## MEMORANDUM

NAC Project No. 323.01 – 19.12

Request: Request for a Preliminary Plan Amendment to the Silver Lake Village  
Planned Unit Development

Property Address: 3800 Silver Lake Road NE

EAST ELEVATION ALONG SILVER LAKE ROAD

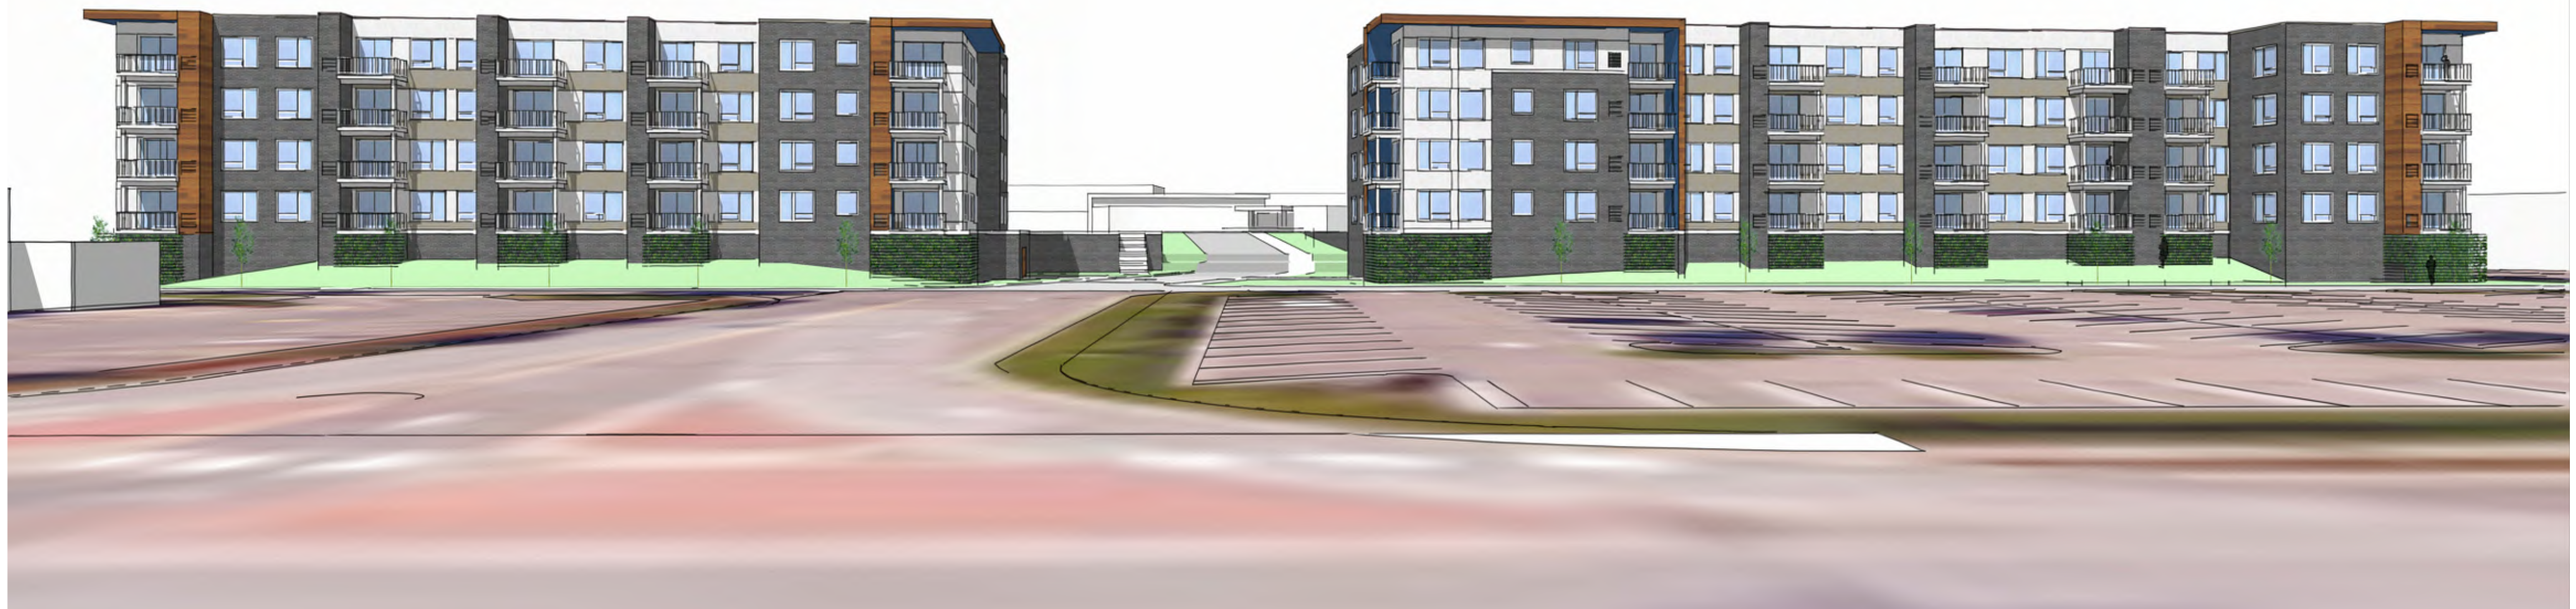
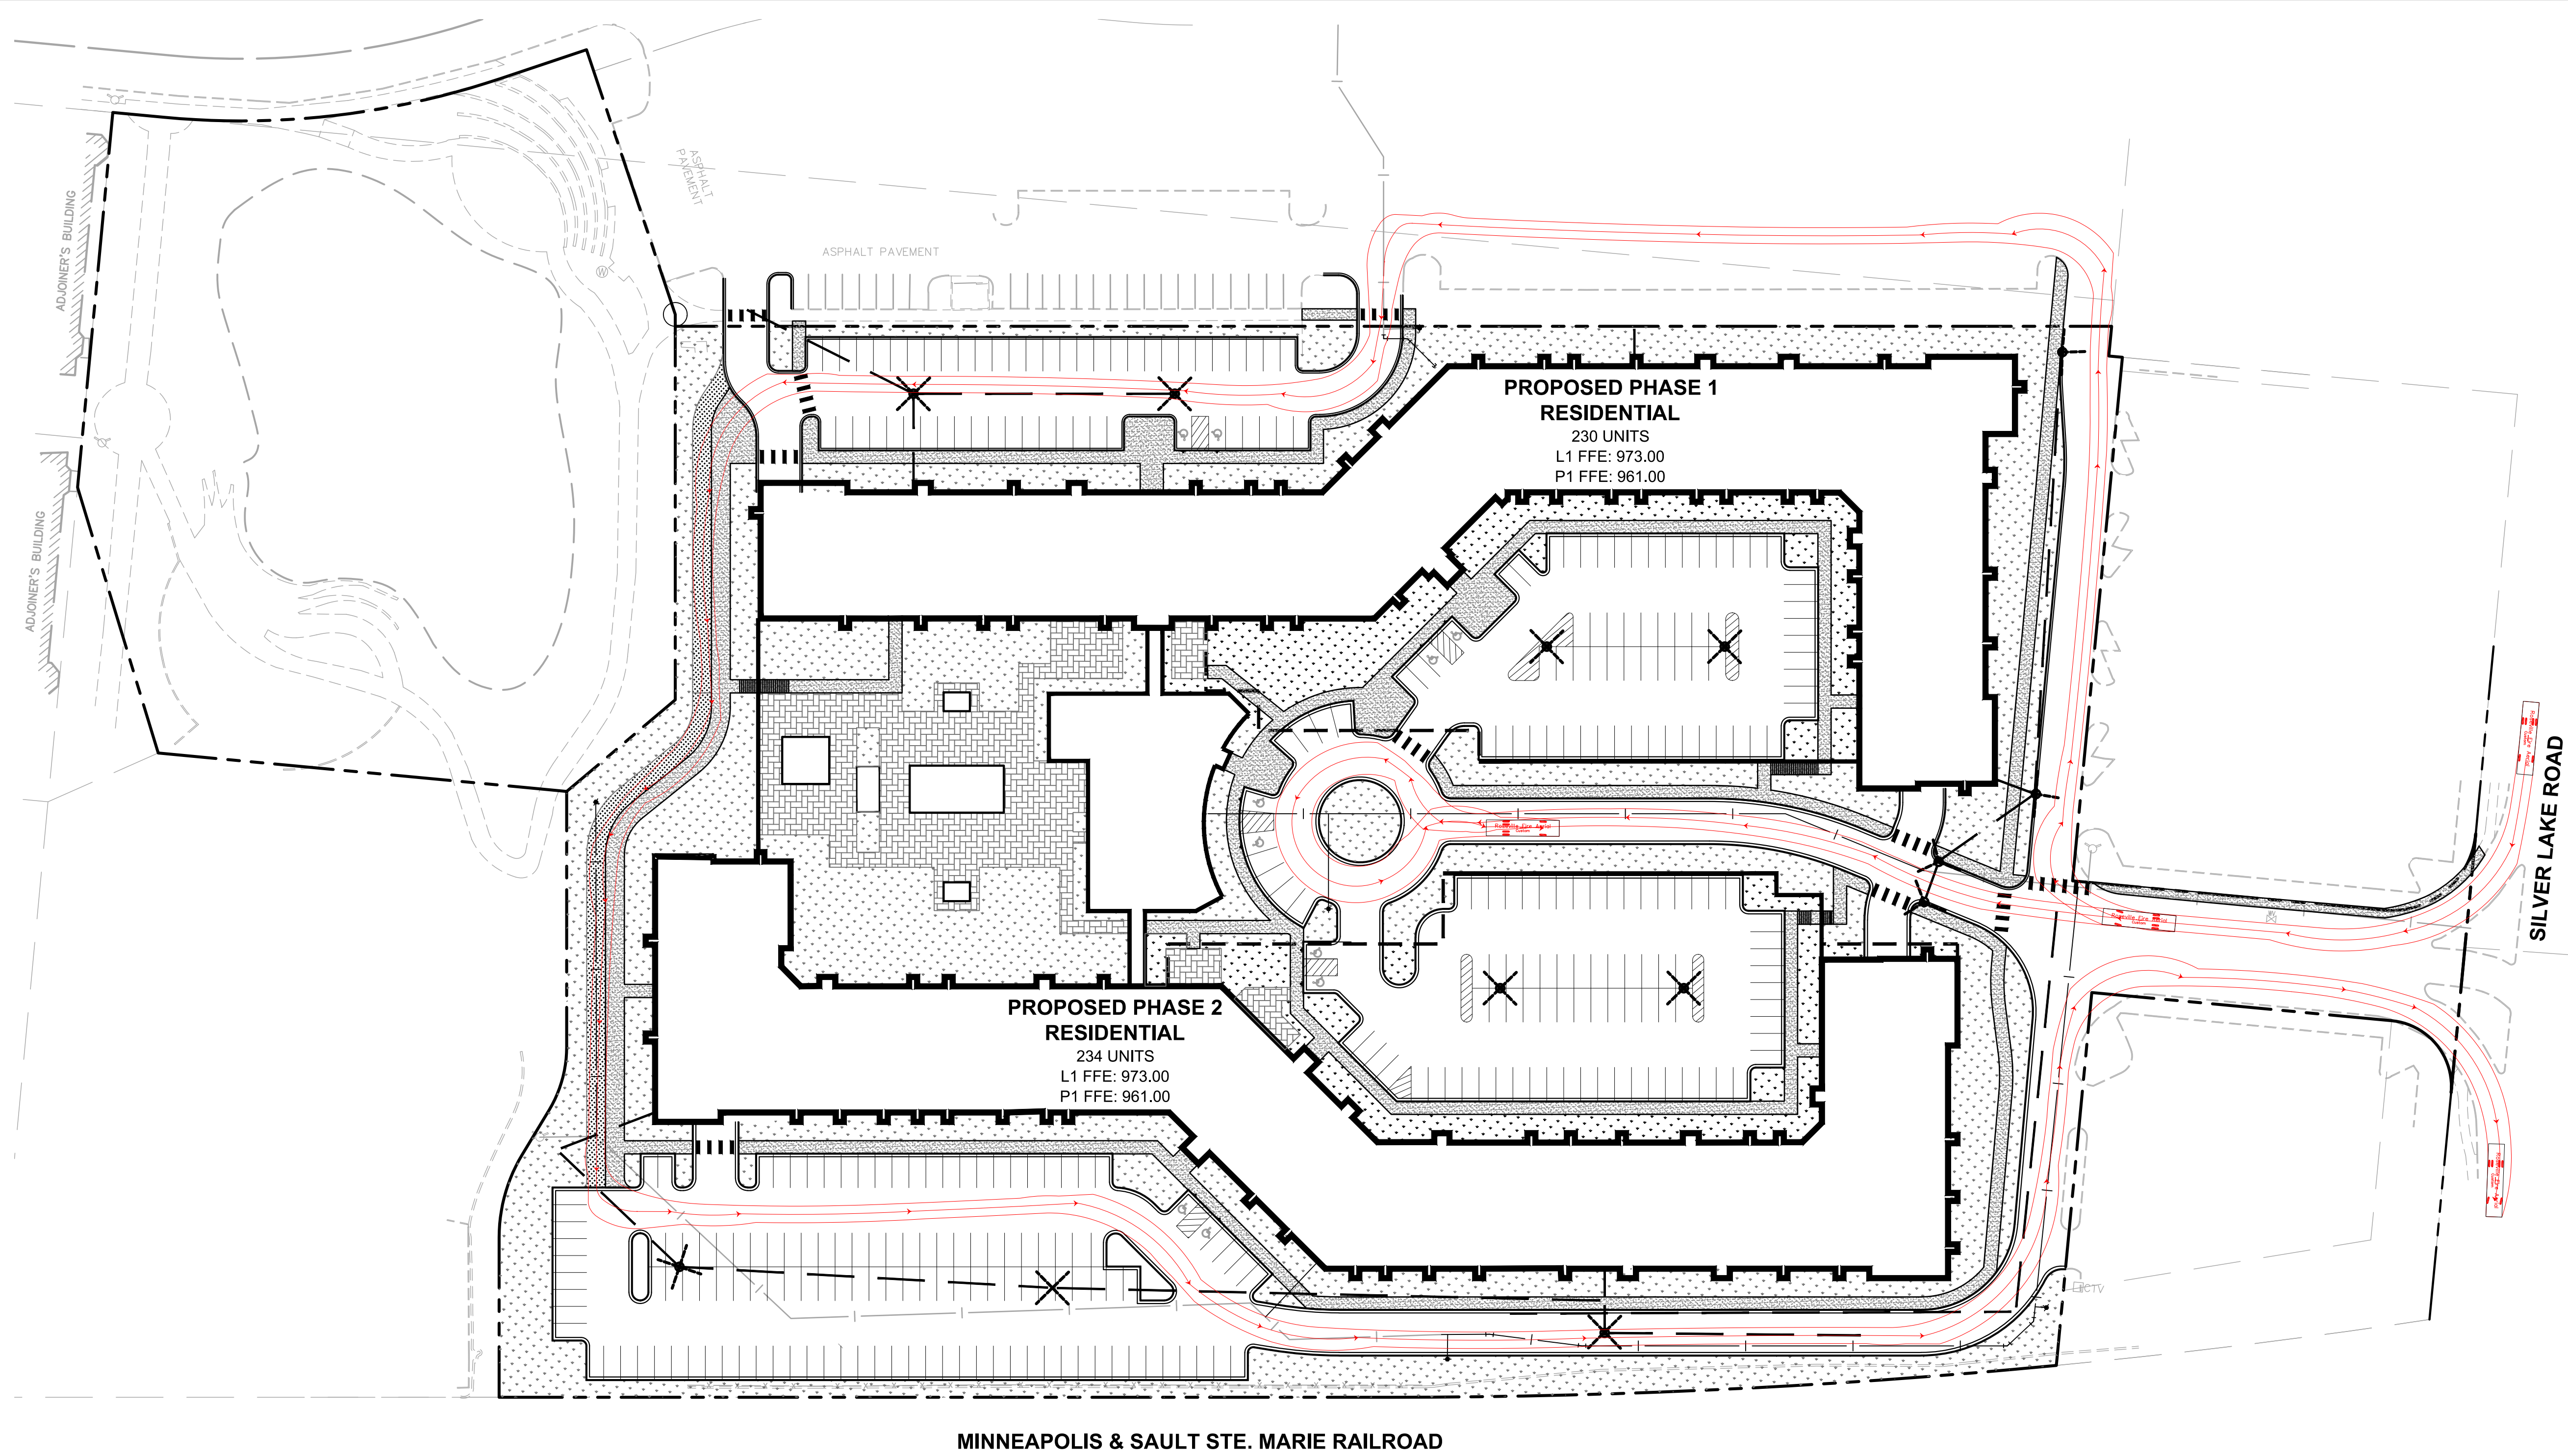
**Building Height.** Both apartment buildings include a ground level parking garage and four floors above the garage which are to be comprised of apartment units. In this regard, the building is five stories in height (52 feet). While the PUD zoning district does not impose a specific height requirement and can provide for “flexibility” in this regard, it is important to note that the City’s R-4, Multiple Family Residential District imposes a maximum height requirement of 3 stories or 35 feet.

The purpose of this recommendation would be to create a more prominent sense of entry to the project. While the main entry/access area inside the interior courtyard appears to be an attractive space, the view of the project from Silver Lake Road is understated – little attention is evident to the “front door” of the project site. Planning staff believes that an enhanced entry drive would benefit the project with the objective of making a more substantial presentation to the public side of the development.

6. Final PUD Plans demonstrate compliance with ADA parking supply requirements (for disabled persons).
7. City Officials find the proposed five-story apartment building heights to be acceptable (within the context of the PUD).

# SITE PLAN

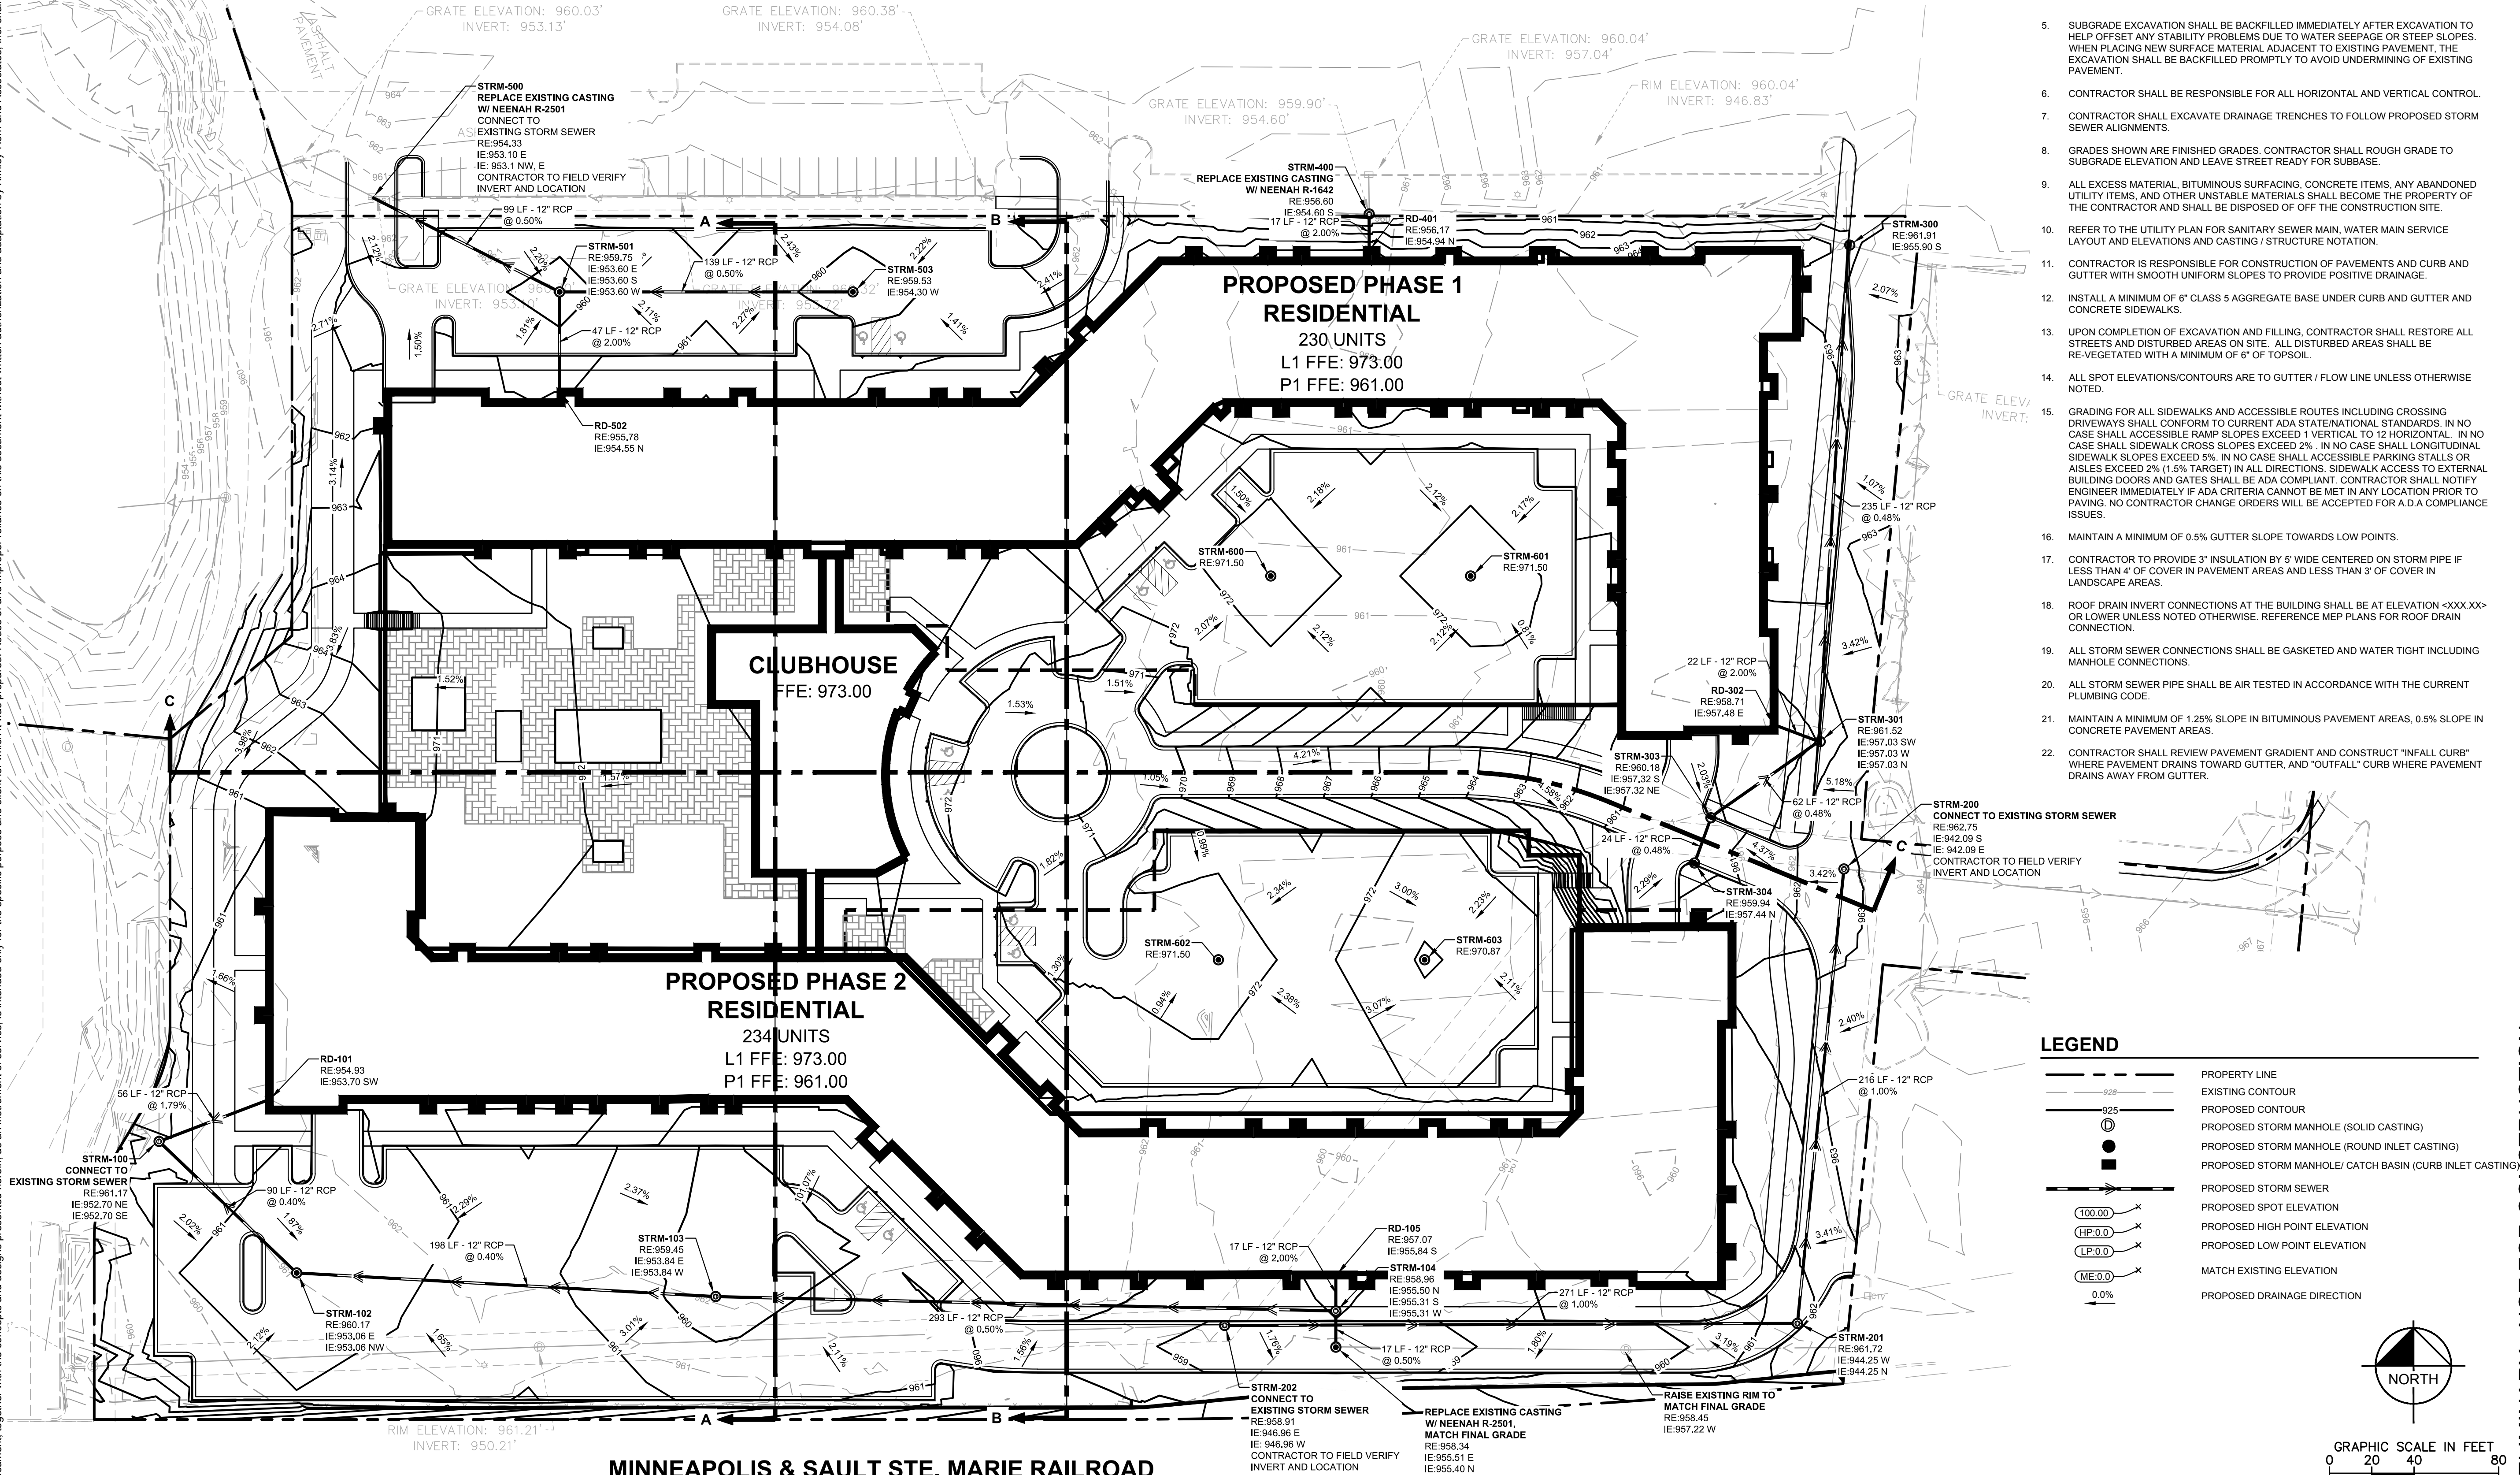
The parking plan for the parking garage has not, to date been provided. Thus, it is not possible to identify the total number of disabled parking stalls which are to be provided. The submitted site plan illustrates 340 surface parking stalls and 10 disabled stalls which is considered adequate.

**Sidewalks, Parks, and Open Space.** The submitted site plan illustrates concrete sidewalks along the south, east and west sides of the site. Sidewalks are also illustrated within the interior court area. Connections to the surrounding area are consistent with the existing conditions, and should serve the site well.

The site establishes an impervious surface coverage of 75% of the development property, apart from the parcel on which Salo Park is located. Current impervious on the site is approximately 85% under the original Walmart use. While the resulting impervious exceeds the R-4 standard, it represents a significant increase in green space over the existing condition. Moreover, a significant portion of the impervious within the courtyard areas of the project will be landscaped and provide recreational amenities available to the residents of the project.

10. As a part of the Final Plan submission, the submitted landscape plan be expanded to specify plant varieties and sizes.
11. Consideration be given to accentuating the primary entrance to the site via an intensified landscaping plan and other elements. Specifically, consideration be given to enhanced architectural features as well as provision of a landscape median near the eastern entrance to the site, between the garage entrance driveways and the sidewalk crossing to the east.
